REQUEST FOR FURTHER INFORMATION - CRC184072; CRC184073; RMA/2019/373

Lands and Survey (South) Ltd have applied for resource consent on behalf of SOL Quarries Ltd to expand their quarry, located at 81 Conservators Road, Yaldhurst.

The purpose of this letter is to provide responses to the questions that have been raised by Environment Canterbury (ECan) and Christchurch City Council (CCC) by way of Section 92 requests for further information.

Figure 1: Proposed Dust Management Plan

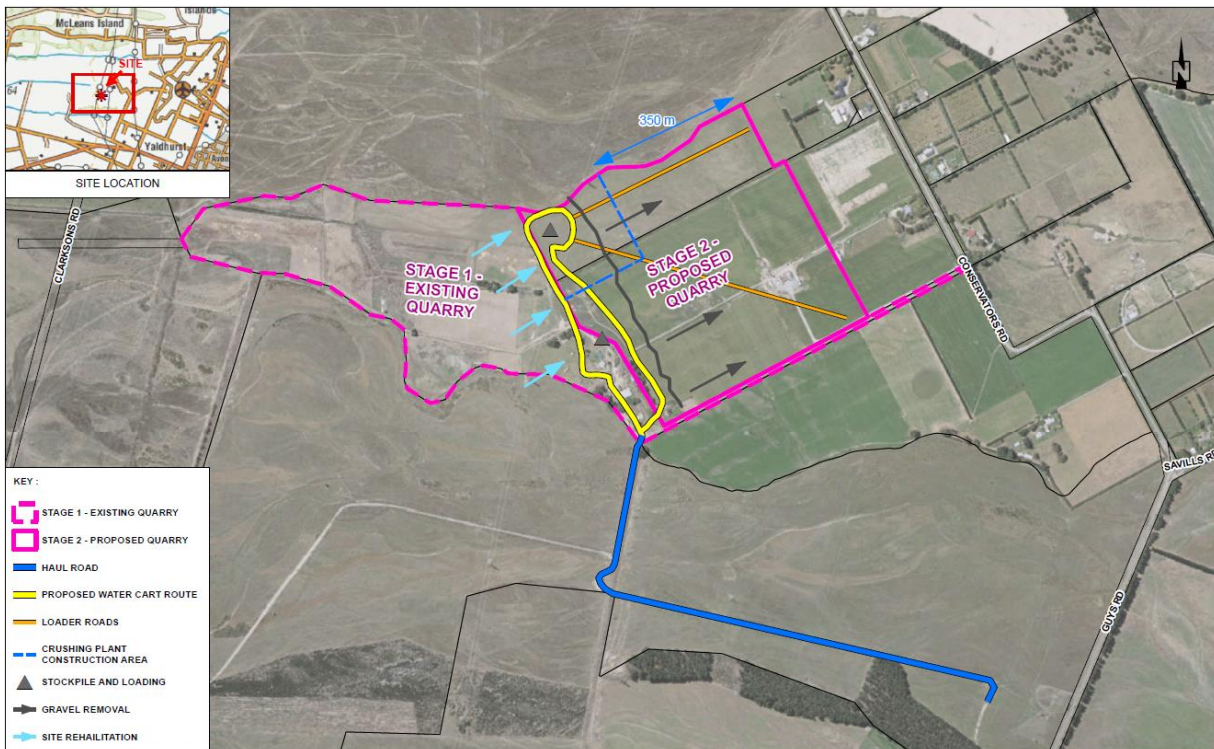
ii. In regard to the surface area that will require dust suppression, please provide clarification on the following matters:

With reference to **Figure 1**, the main haul road length has been measured as being 1.3 km in length from the end of the chip sealed entrance to the weigh bridge. In order to minimise the dust creation potential and consequently reduce dust suppression water demand, the main haul road has been surfaced with crushed used asphalt which has lower dust generation propensity than gravel.

Figure 4: Downwind impact arc for 113 Conservators Road

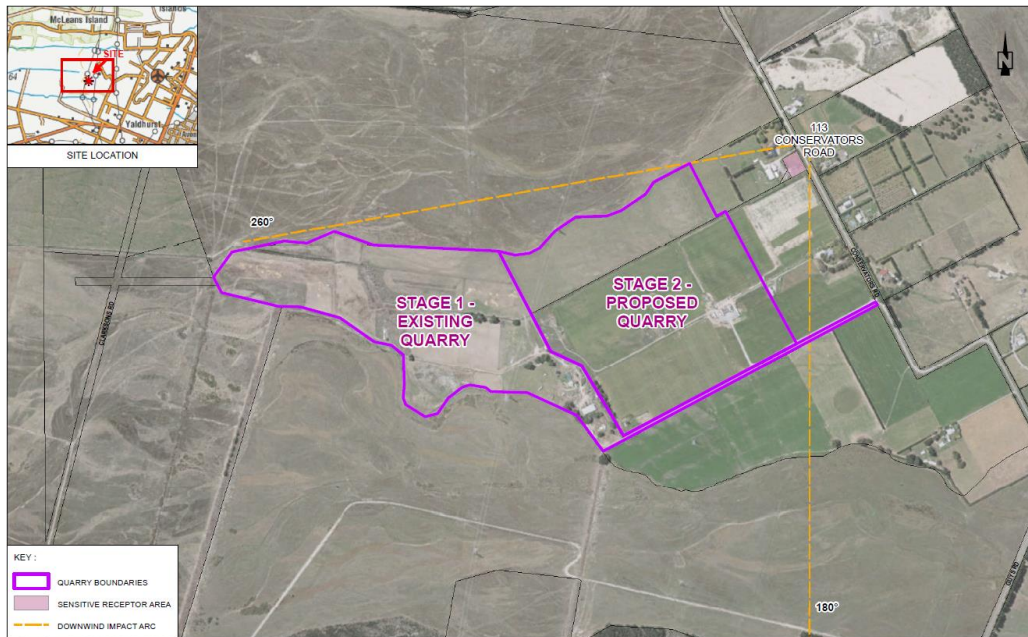
Please provide a more detailed assessment of the potential exposure of the residence at 113 Conservators Road, Yaldhurst to potential dust events from the proposed quarry activity. This assessment should include consideration of any additional mitigation measures to address potential impacts, particularly when quarry operations come within 250 metres of that residence.

Figure 4 shows the location of 113 Conservators Road and the corresponding downwind impact arc relative to the current and proposed operations (including the heavy truck haul road). The residential sensitive receptor at 113 Conservators Road is located to the northeast of the proposed quarry site as shown in **Figure 4**. The downwind impact arc is also shown which indicates the wind directions considered when analysing which winds cause the sensitive receptor to be downwind from the proposed quarrying activities. Wind directions blowing from between 180 and 260 were used for wind analysis calculations when considering this receptor.

The downwind impact arc for the sensitive receptor at 113 Conservators Road has been defined as 180-260 from the receptor, including almost the entire southwest quadrant. The distance from the receptor to the boundary of the proposed quarry site is over 200 m and the proposal includes plans to ensure that the crushing plant which is associated with the highest potential dust risk is located a minimum of 350 m from the receptor, at the western end of the proposed site.

Figure 6: Frequency of wind speeds >5 m/s on dry days blowing towards 113 Conservators Road in summer

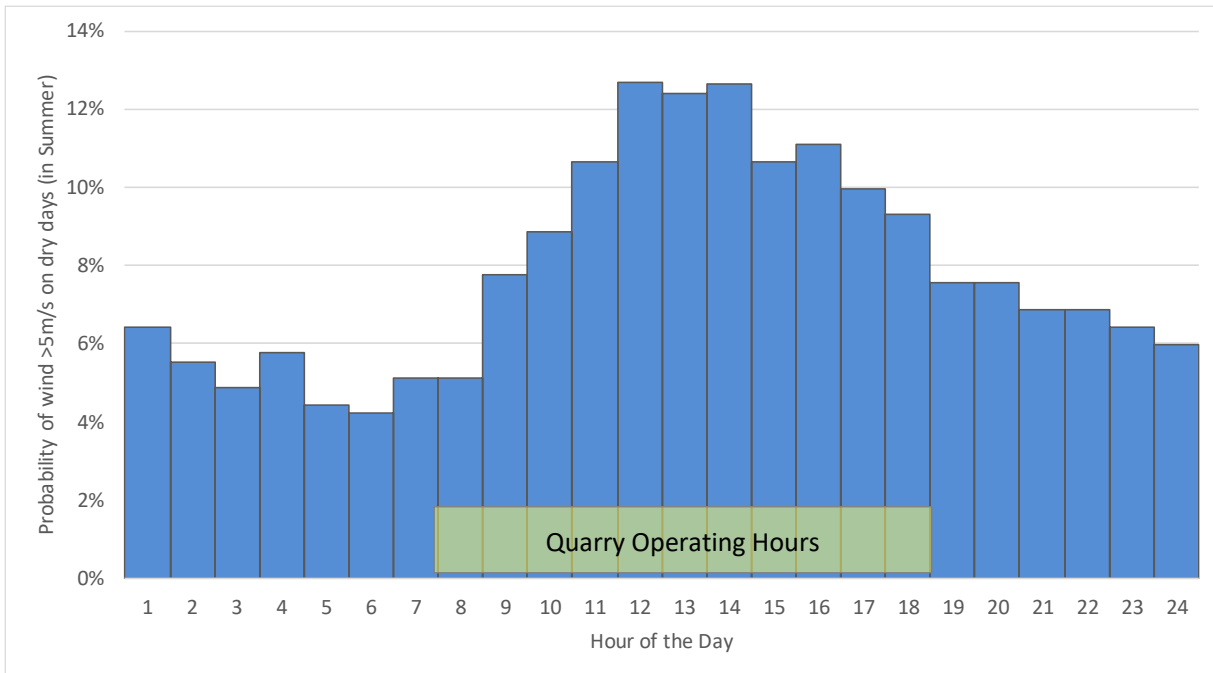
- i. *Based on the above, please clarify what is considered to be a more reasonable water application and provide an updated assessment regarding the use of water for dust suppression. In this consideration, please include water that will be consumed during*

Based on the wind speed data analysis above (see **Figure 6**) PDP also suggests that SOL Quarries' dust management approach could be amended to focus water application for dust suppression to the hours when wind speeds are greater than 5 m/s i.e. in the 6 hours in the afternoon. If the full 100 m³ of available water were used for dust suppression during this time, this would increase the potential intensity of water

Figure 15. Location of the meteorological monitoring site (blue circle) and indicative area for the PM₁₀ monitoring (red circle).

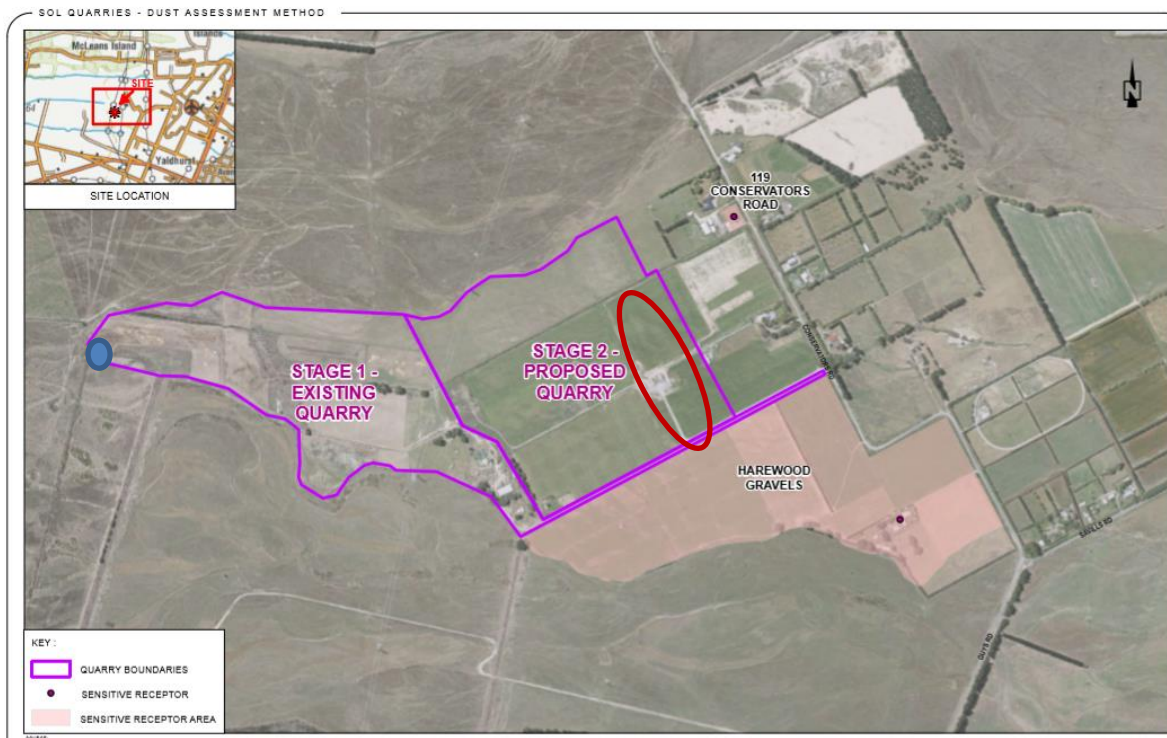
The Air Quality Assessment indicates that monthly PM₁₀ and Total Suspended Particulate (TSP) monitoring will be undertaken on the northeast boundary of the site to demonstrate the effectiveness of the control and mitigation measures. It is stated that detail of this is provided within the 'Draft Dust Management Plan'. However, no details of this have been provided. Please provide:

One of the key elements of SOL Quarries' air quality monitoring programme is a 10 m high meteorological mast carrying windspeed, wind direction, temperature and relative humidity sensors. A rain gauge is installed alongside the meteorological mast. The meteorological mast has been installed on site and is located on the western boundary of the site. Because of the surrounding flat terrain while it is located on the western end of the site the instruments will provide data that is representative of conditions being experienced across the entire site. The meteorological sensors on the mast are currently not fully functional but a complete maintenance service and re-calibration is scheduled for the site in the near future. The data from the meteorological site is telemetered via a cellular network to Harvest.com where it is available for real-time viewing and analysis on that website.

The second key element to SOL Quarries' air quality monitoring programme will be a PM₁₀ monitor. The PM₁₀ monitor is likely to be a nephelometer (light scattering) instrument which provides real-time PM₁₀ measurements which along with the meteorological data be telemetered to the Harvest website. The PM₁₀ monitor will be set up on a steel frame and be powered by batteries which are recharged by solar panels. This configuration allows the PM₁₀ monitor to be quickly and easily relocated (within say 2 hours) to capture PM₁₀ concentrations when the wind is blowing toward nearby sensitive receptors.

Figure 17 shows the location of the meteorological mast (blue circle) and an indicative area (red circle) within which the PM₁₀ monitor is most likely to be operated to capture PM₁₀ concentrations. **Figure 17** shows a photo of the PM₁₀ monitor set up.

Figure 17: 1-hour average PM10 concentrations at Site 1

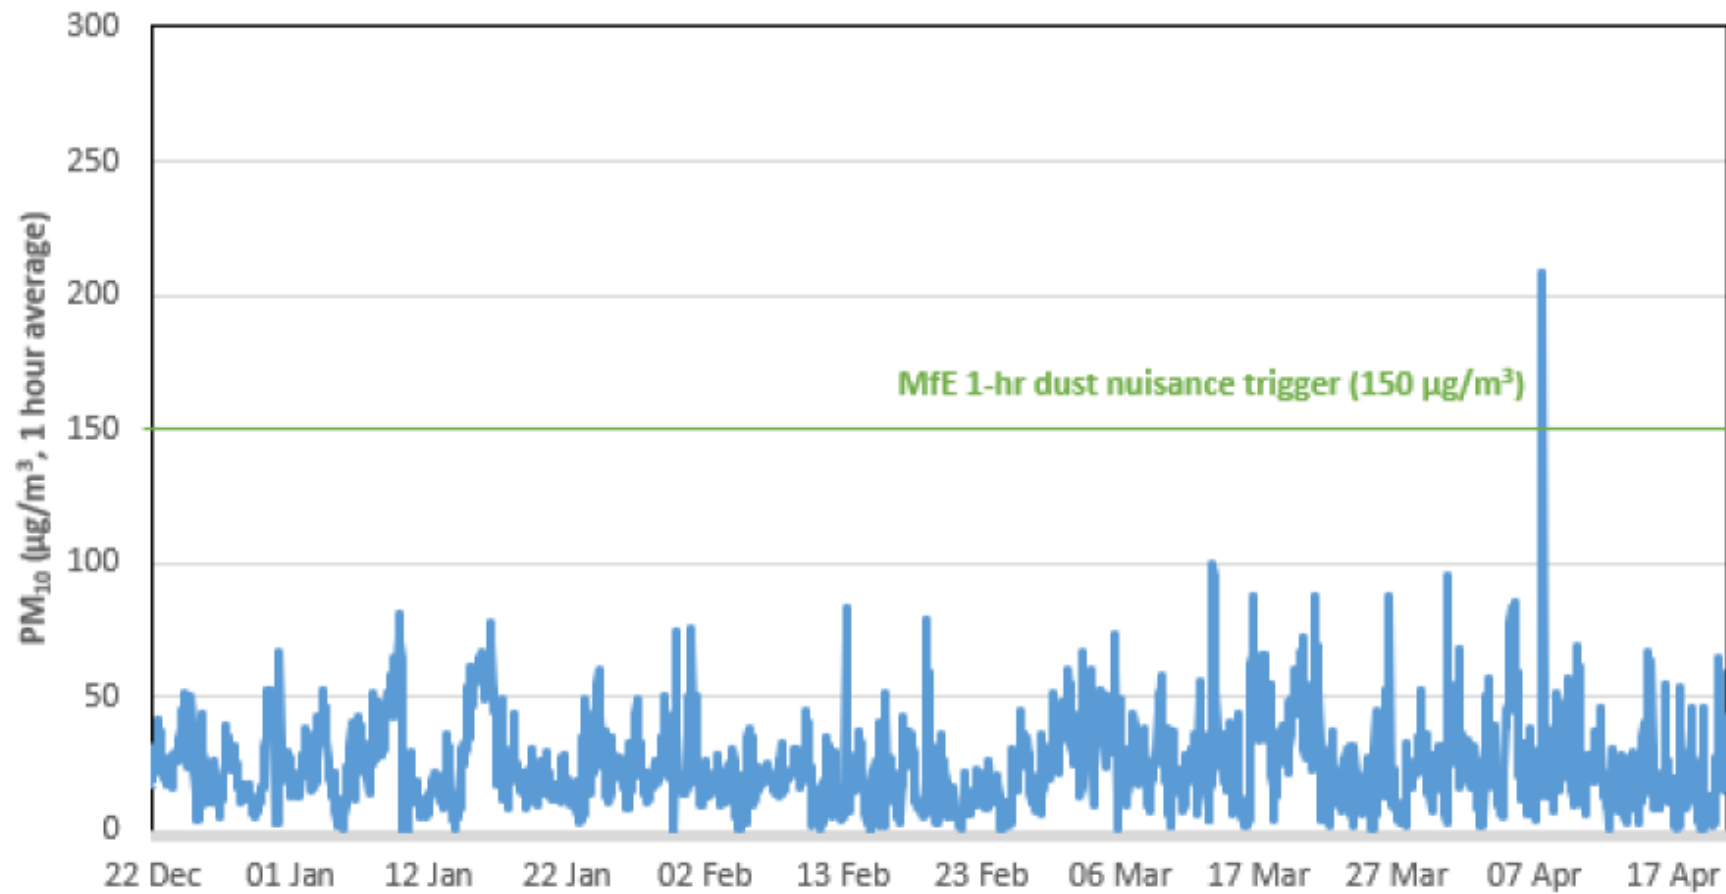
Please provide details of the existing dust levels at the nearest residential properties. This will require dust monitoring on a number of days with different weather and wind conditions.

The 1hr average PM₁₀ concentrations at Site 1 are shown below in **Figure 17** which had been reproduced from the Mote report (originally Figure 5 on page 13).

It can be seen from **Figure 17** that the MfE 1-hour dust nuisance trigger value of 150 µg/m³ was exceeded twice on Saturday the 7 April 2018. These exceedances occurred at 8.00pm-9.00pm and from 9.00pm-10.00pm New Zealand Standard Time. Both these periods are outside the operating hours of the quarries and occurred when a northerly wind was blowing i.e. not from the direction of the quarries.
